Applicant: Chick-Fil-A

SUBJECT: Preliminary & Final Site Plan w/Variance Application No. SP-6/23
Chick-Fil-A, 2950 Brunswick Pike
Tax Map Page 36.01, Block 3601, Lot 1.01

Re: **Chick-fil-A Inc.**
Preliminary & Final Major Site Plan with Bulk Variances
Block 3601 Lot 1.01
2950 Brunswick Pike
HC District

SUBJECT: Chick-fil-A, 2950 Brunswick Pike
Preliminary & Final Site Plans w/Variance Application No. SP-6/23
Planning Board Memorandum #1
Lawrence Township Mercer County, New Jersey
Tax Map Page 36.01, Block: 3601, Lot:1.01

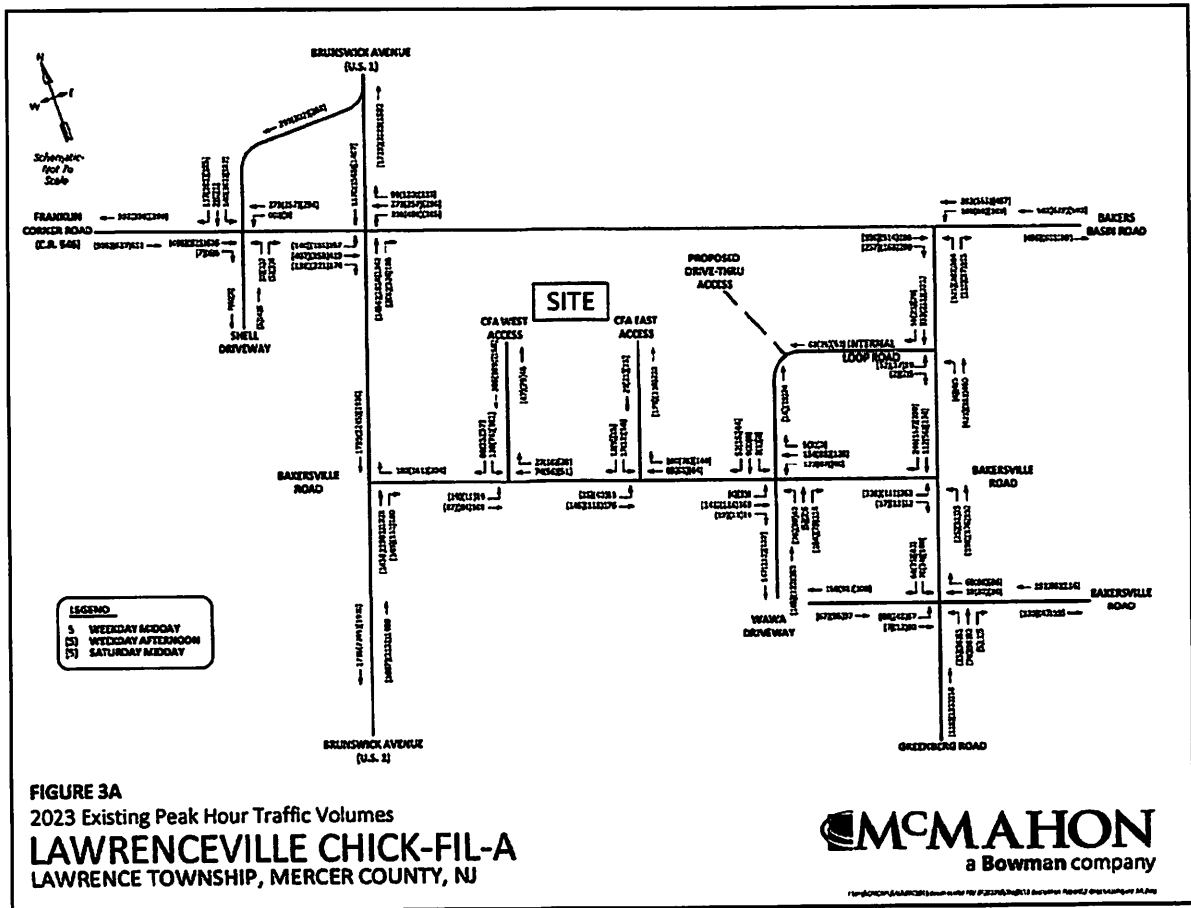
3. The numbers shown in Table 2 above do not match up with the movements shown in Figure 3A “Existing Peak Hour Traffic Volumes”. For example, during Weekday Midday hour, Table 2 says the Local Rate IN is 251, Figure 3A (as depicted below) shows 259 entering. Similarly, Table 2 says 249 OUT, Figure 3A shows 235 exiting. Similar discrepancies are noticed during the Weekday Afternoon as well as Saturday Midday time periods. Please address this concern.

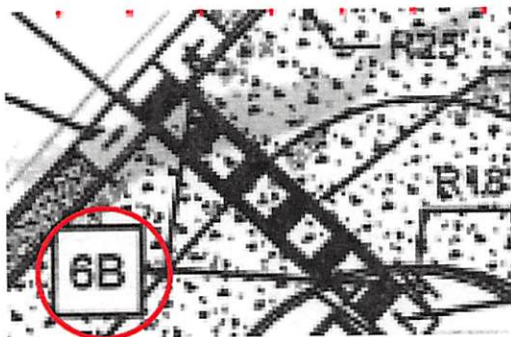
5. The proposed three drive-through lanes connect directly to the shopping center internal circulation roadway on a horizontal curve. This proposed roadway layout is not desirable due to lack of gap between circulation driveway as well as sight distance issue. We anticipate that the customers will queue up and will eventually block the traffic movement along internal circulation road. The layout of the proposed drive-through lanes should be revised so that a sufficient gap is provided from the internal circulation driveway to the starting point of the drive-through lanes. Additionally, the proposed drive-through should not be placed on a roadway curvature.

R6-1

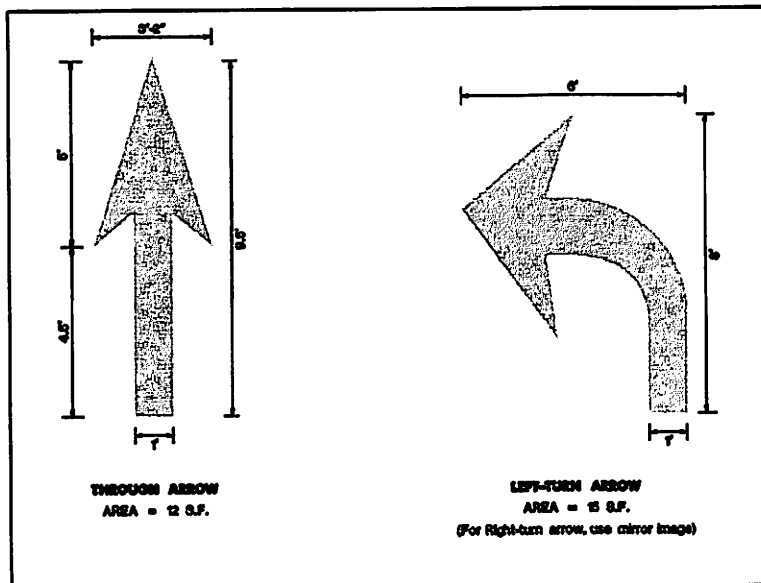
13. The West Driveway Exit Only should have proper R6-1 Left and Right One-Way Signs (36" wide x 12" tall) placed back-to-back on both sides of the driveway facing Bakersville Road traffic.
